HISTORIC AND DESIGN REVIEW COMMISSION

HDRC CASE NO: 2022-517
ADDRESS: 830 W COMMERCE ST
LEGAL DESCRIPTION: NCB 284 BLK 23 LOT E 14.2 OF 1, 2 & W 45.6 OF 3 ARB A2
ZONING: D, H
CITY COUNCIL DIST.: 5
DISTRICT: Cattleman Square Historic District
LANDMARK: Individual Landmark
APPLICANT: Sue Ann Pemberton/Mainstreet Architects Inc.
OWNER: Dix Densley/DGSD-830 W COMMERCE ST LLC
TYPE OF WORK: Construction of a 3-story addition and rooftop addition, exterior modifications
APPLICATION RECEIVED: September 30, 2022
60-DAY REVIEW: Not applicable due to City Council Emergency Orders
CASE MANAGER: Rachel Rettaliata

REQUEST:

1. Reconstruct the 1-story building on the east side of the structure with a second-story addition.
2. Construct a 3-story rear addition.
3. Install a new steel balcony and exterior staircase on the south (rear) elevation.

WINDOW ELEVATIONS

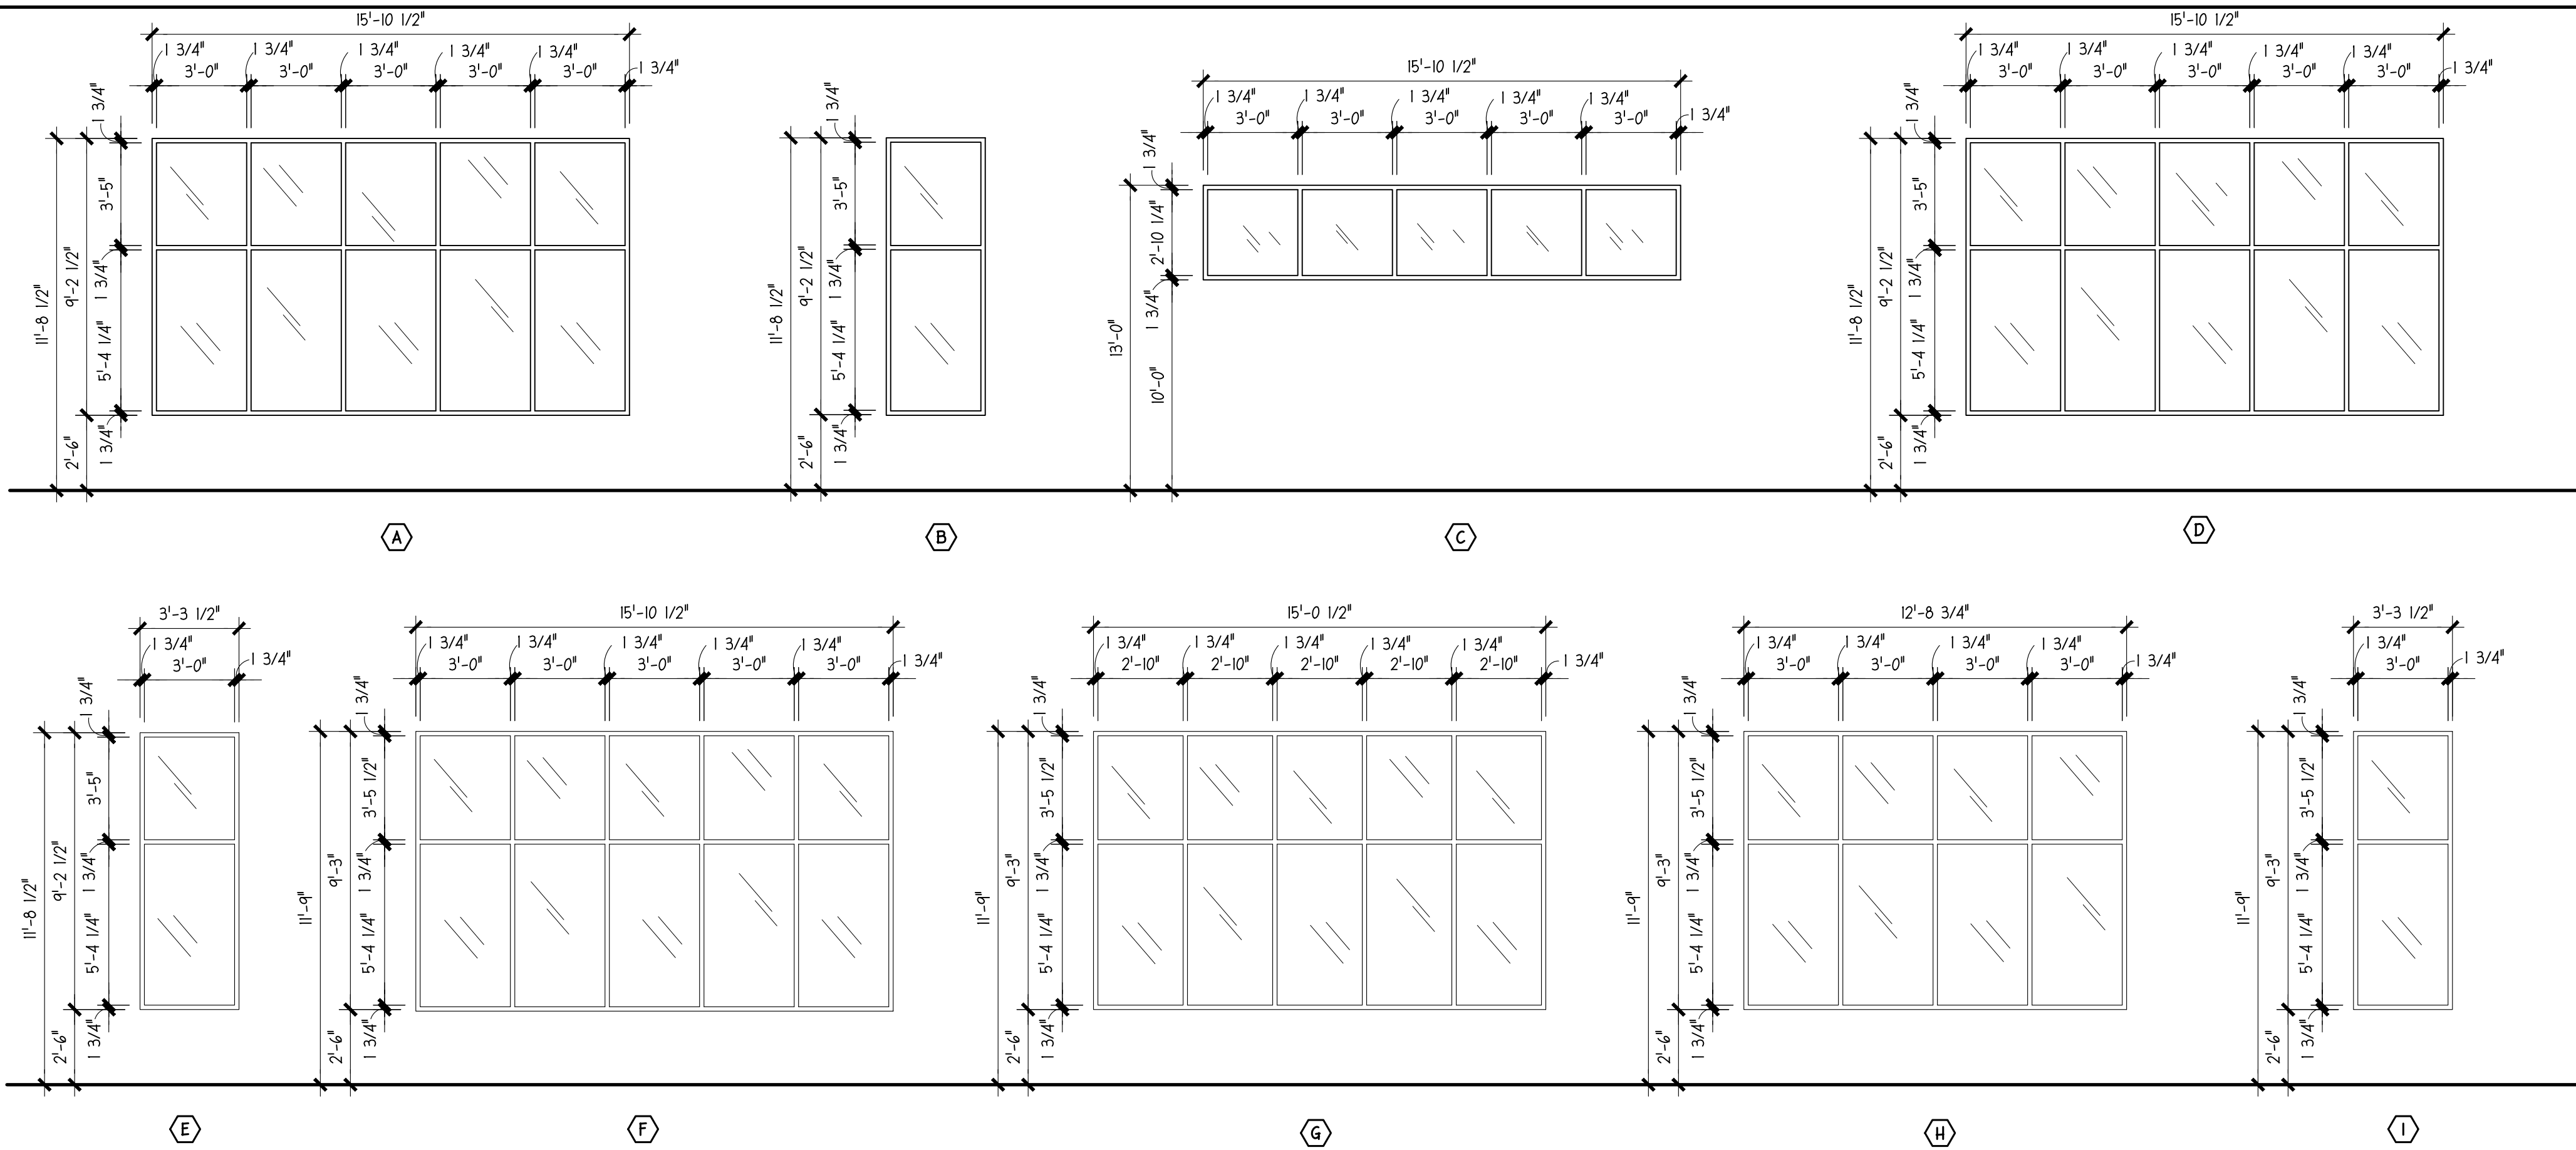
feature traditional dimensions and an architecturally appropriate sill detail. Window track components must be painted to match the window trim or be concealed by a wood window screen set within the opening. Faux divided lites are not permitted. ***This stipulation has NOT been met.***
